MONTGOMERY COUNTY HISTORIC PRESERVATION COMMISSION
STAFF REPORT

| Address: | 7203 Cedar Ave., Takoma Park | Meeting Date: | 12/7/2022 |
| Case No.: | 1011274 | Tax Credit: | Partial |

Proposal: Roof alteration, dormer construction, fenestration alteration, window replacement, and after-the-fact front porch alteration.

A001

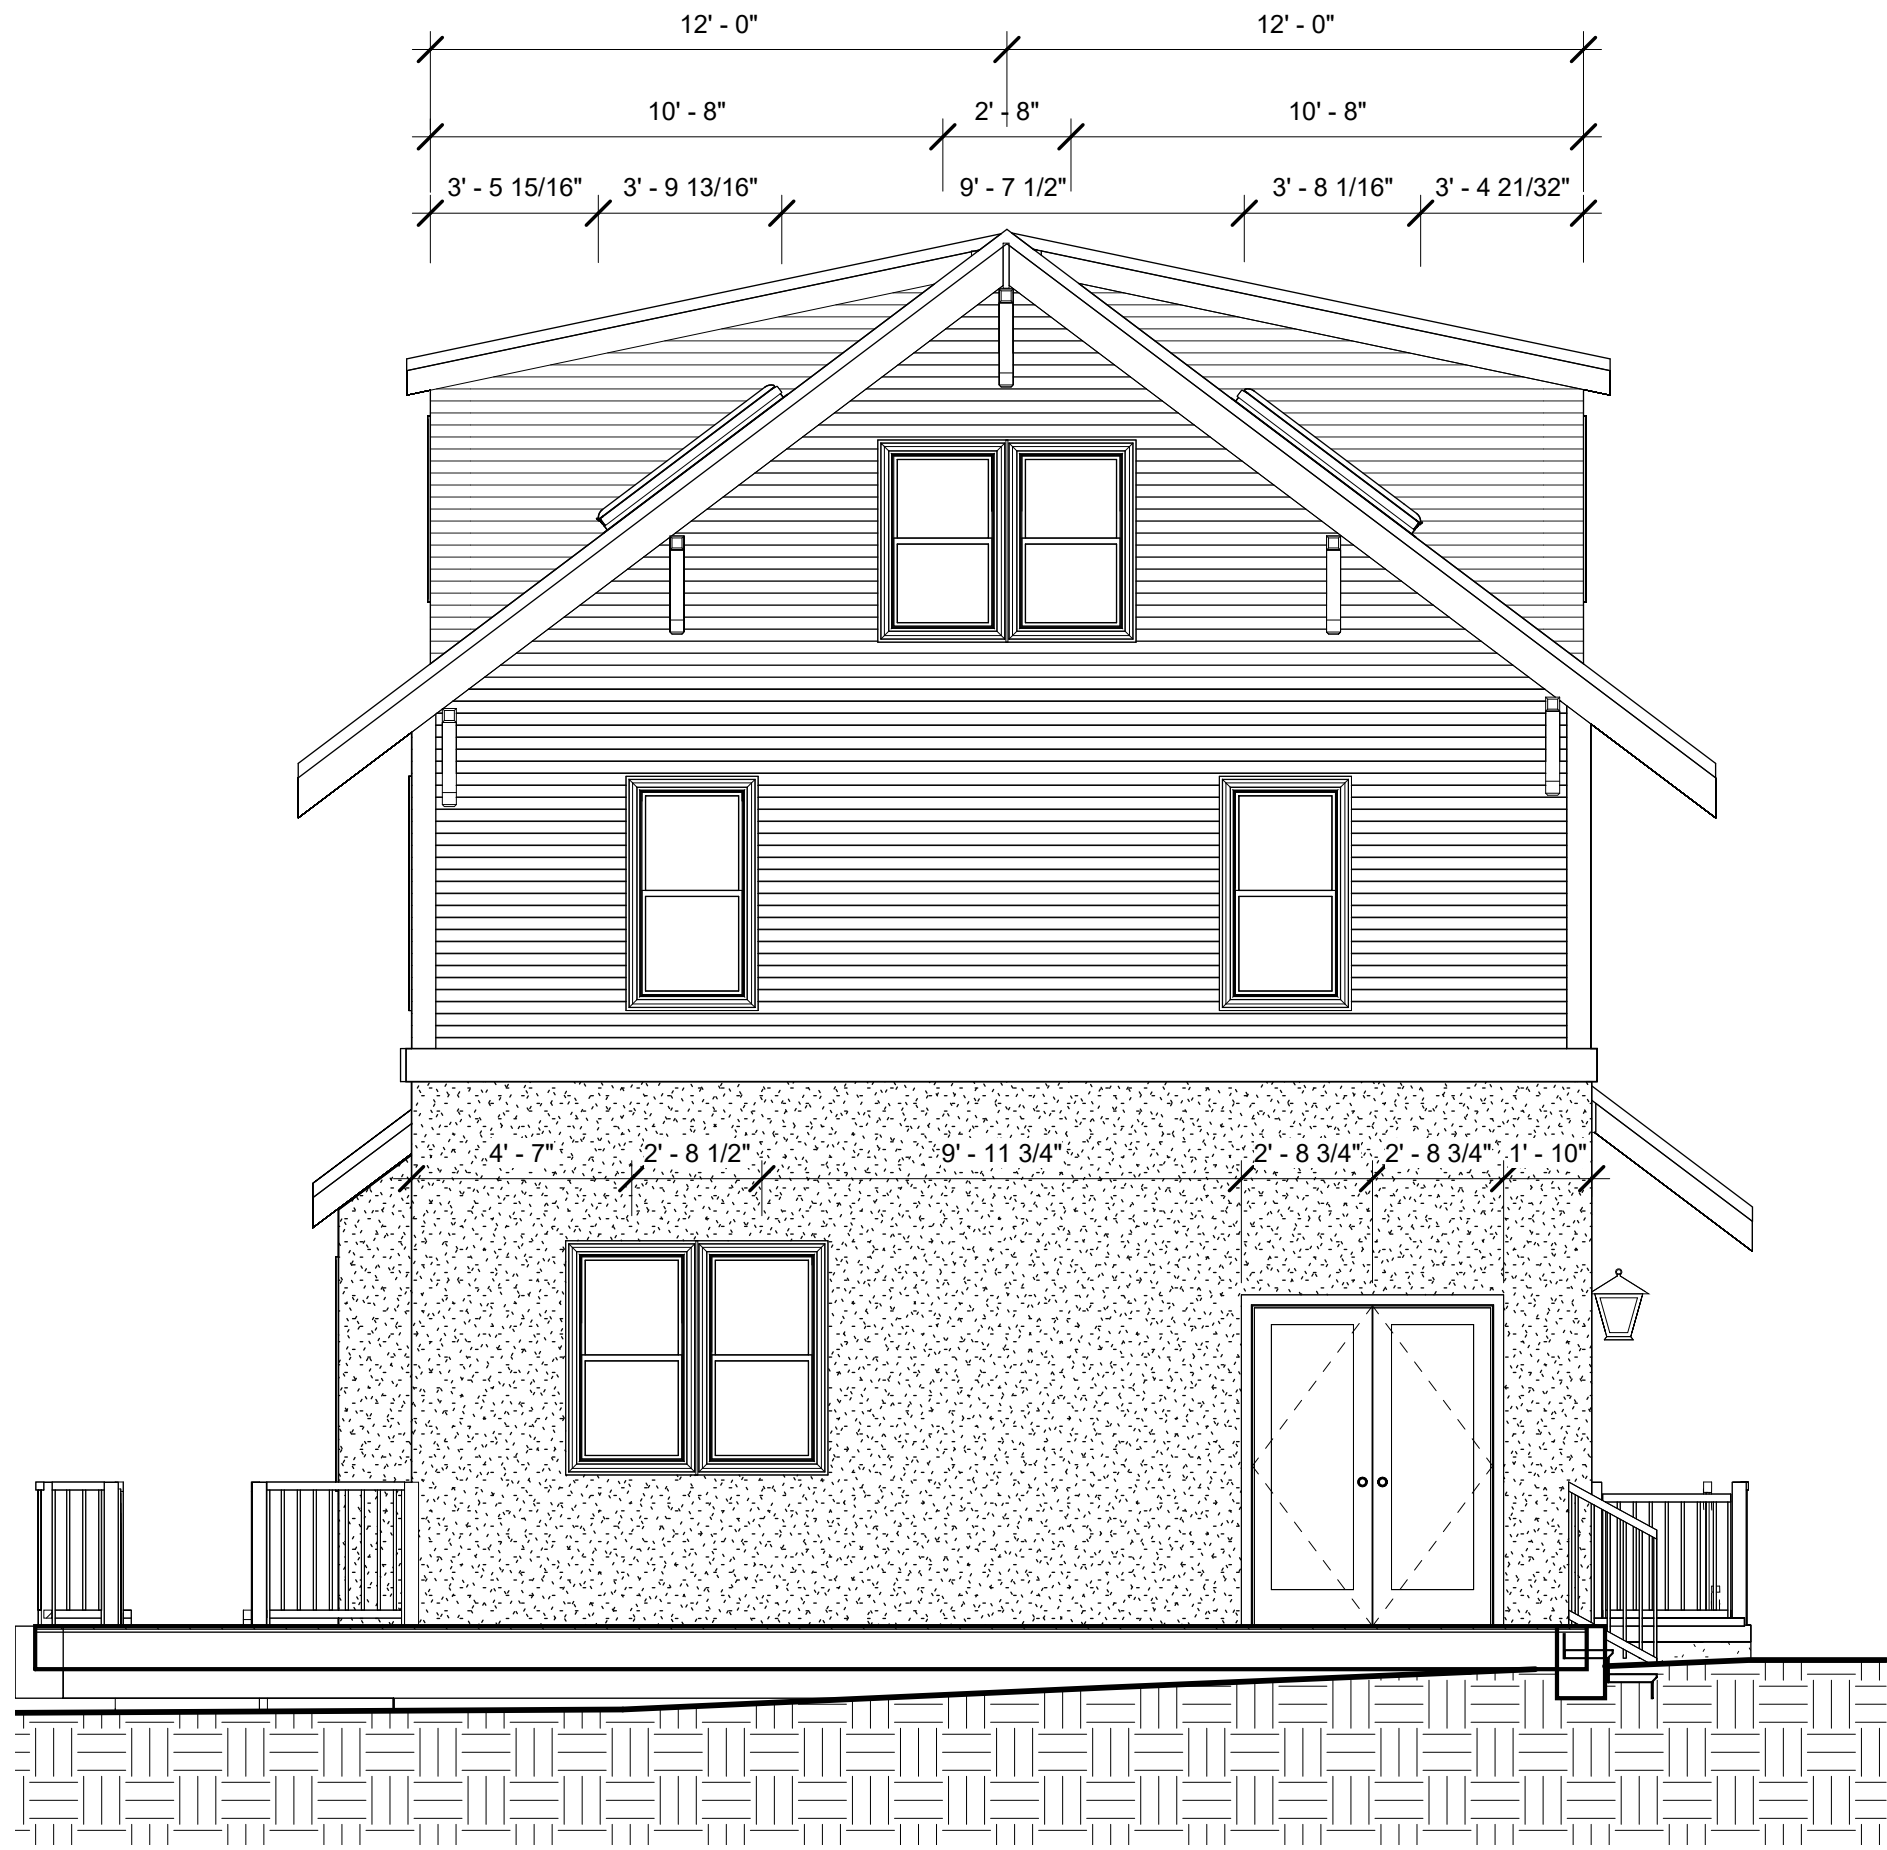
Above the left side door is a ghost of a previously installed roof. The applicant states that rain can enter directly into the basement and proposes installing a roof over the door to shed rain away from the house. The proposal is to construct a shed roof with exposed rafter tails, to match the roof design, over the side porch.

The HPC was supportive of this proposal at the Preliminary Consultation and did not state a preference for a specific roof form. Staff finds the ghost in the stucco is evidence that there had been a shed roof over this entrance at some point in the building's history. Staff additionally finds that the proposed roof will not have a substantial impact on the house massing on the highly visible side elevation and recommends the HPC approve the shed porch roof.

To effectively evaluate the proposed sash pack, the HPC requested measured drawings of the existing sash and the proposed sashes. The elevations show the stiles are ¼” wider than the existing, that the meeting rail is 7/8” wider than the existing, and that the bottom rail is ¼” taller than the existing. This is fairly typical of a sash pack assembly because the jamb liner shrinks the amount of glazing. While Staff encourages the applicant to restore the existing sashes and utilize the County Historic Preservation Tax Credit, Staff finds that the proposed sash pack is similar enough in dimensional profiles to the existing window dimensions to be compatible. Additionally, the HPC consistently determined – where replacement was acceptable – that aluminum clad windows are appropriate replacements to Contributing resources in the Takoma Park Historic District. Based on the feedback from the HPC at the Preliminary Consultation and the additional documentation presented, Staff recommends the HPC approve the window replacement under the *Design Guidelines*.

At the rear of the house, the applicant proposes to remove the paired sash windows, non-historic half-lite door, and blocked-in window. In their place, the applicant proposes to install a pair of French doors on the right side of the rear elevation and a pair of sash windows on the left side of the rear elevation.

The Takoma Park *Design Guidelines* are quite permissive on alterations to elevations that are not visible from the public right-of-way. The *Guidelines* state alterations not visible from the public right-of-way should be approved as a matter of course. While a majority of the HPC supported this change, there was at least one dissenter who voiced support for retaining the fenestration as it is. Staff finds aluminum clad windows and doors should be approved at this elevation, however, a specification was not included in the application materials. Staff recommends the HPC delegate final approval authority to Staff to confirm that the new rear windows and doors are either wood or aluminum clad.

The applicant proposes raising the roof ridge by three feet and enlarging the window under the gable to accommodate a pair of sash windows on the front and rear elevations. The applicant provided additional information at the preliminary consultation that the roof rafters were under-engineered and the structure needed to be removed and replaced regardless of whether the HPC allowed the roof ridge to be raised. Based on this evidence, the HPC uniformly supported raising the roof ridge provided the decorative elements, including the siding, brackets, and exposed rafter tails were maintained. The HPC acknowledged the change in grade on the site would reduce the visual impact of the additional height and supported the alteration under the *Design Guidelines*.

The single fixed window under the gable will be replaced by a pair of aluminum-clad sash windows smaller than the ones on the first and second floors. The new sash windows will be consistent with the sash packs installed on the lower floors to match the profiles. Staff finds the new windows will not substantially alter the character of the house and recommended the HPC approve the new windows under the *Design Guidelines* and 24A-8(b)(1).

On the right roof slope, the applicant proposes to install a shed dormer 16' (sixteen feet) wide with a roof projection of over one foot on each side. The dormer will have wood siding with a narrow reveal to match the second-floor siding on the existing house. The two pairs of sash windows will match the attic windows under the front and rear gables. The size of the proposed right-side dormer is reduced significantly from what was presented at the Preliminary Consultation.

As shown in Figure 3, this roof surface is visible from the intersection of Tulip and Cedar Ave., but only from a very narrow perspective. At the Preliminary Consultation, the HPC agreed with Staff's finding that a dormer could be accommodated on that roof slope, but it needed to be significantly reduced in size. Staff finds the proposed width is significantly reduced and is generally consistent with the guidance provided by the HPC and is set far enough to the rear that it will not have a significant impact on the streetscape. Staff additionally finds that the materials and architectural details are consistent with the house architecture as supported in the *Design Guidelines*.

On the left roof slope, the applicant proposes to construct a shed dormer matching the dimensions and appearance of the right-side dormer (Staff notes that this dormer is drawn incorrectly, as it is represented as projecting above the roof ridge). At the Preliminary Consultation submission, the applicant proposed a gable dormer on the left roof slope. The HPC supported this dormer in concept, but could not provide additional feedback because dimensions and materials were not included with the application.

Staff would prefer a gable dormer over the proposed shed dormer because it has a smaller apparent mass. The application states this element was changed to a shed dormer because accommodating the stair and landing would require a gable more than half the width of the roof plan. Regardless of why the proposal was changed, Staff does not find that the proposed shed dormer is an appropriate feature on the left side of the building. The proposed dormer, which aligns with the left wall plane, would add an additional 6' 1 7/16" (six feet, one and seven-sixteenths inch) to the vertical wall plane. Unlike the right elevation which has projections for the chimney and the bay in the dining room, the left elevation is a single, flat plane. Staff finds extending that plane will negatively impact the house's apparent mass and is too dramatic of a change to be supported under either the *Design Guidelines* or any of the provisions in 24A-8(b). While Staff is supportive of the rest of the proposed work, Staff recommends the approval of this HAWP not extend to the left side dormer. An amended HAWP for a different treatment can be submitted at a later date.

While Staff generally disfavors skylights this far towards the front wall, in this instance Staff finds the visibility of the skylights will be significantly reduced by the rise in grade on the site and the roof height from the right-of-way. Because only the right front skylight will be visible from the right-of-way, Staff recommends the HPC approve the new skylights under the *Design Guidelines* and 24A-8(b)(1).

1. The front porch stairs need to be finished with either masonry or wood, not a composite substitute. Final approval authority to ensure this condition has been satisfied is delegated to Staff.
2. Specifications for the first-floor rear windows and doors was not provided with the HAWP application. Staff recommends the HPC approve wood or aluminum clad windows and delegate final approval authority to Staff to confirm the condition has been satisfied.
3. Any modifications to the chimney need to be submitted to the HPC as a Staff Item/revision to the HAWP for consideration at a future HPC meeting.
4. The approval of this HAWP does not extend to the left-side shed dormer. Permit drawings may not include this dormer. An amended HAWP with a revised proposal can be submitted under this permit number;
